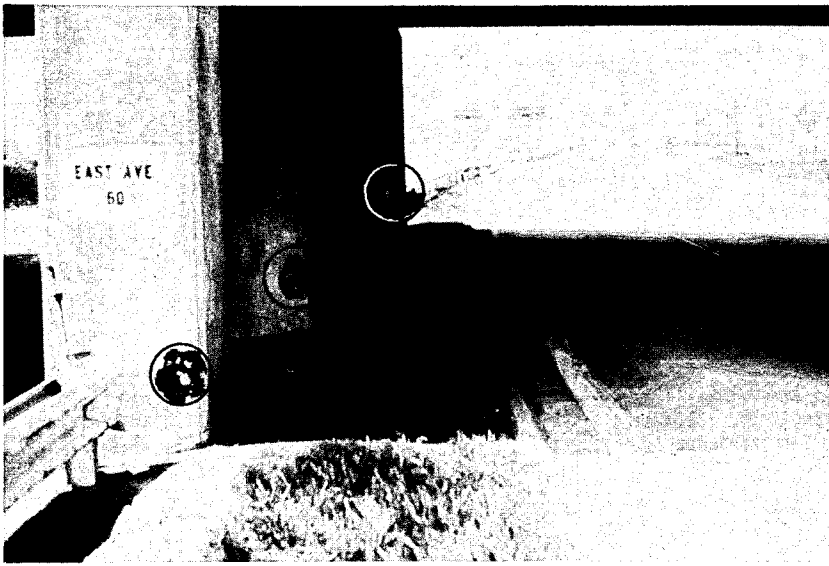
nice and easy. I feel you need a crash program to get all these hazards off our roadways. It is an interstate highway and the speed is high here.

Here you can see the sign could be mounted on top of the overpass and the pole could be put inside the center divider. Every one of these places is an extra snag. Even at the bridge support, the guardrail does not go around it; it stops in the center.
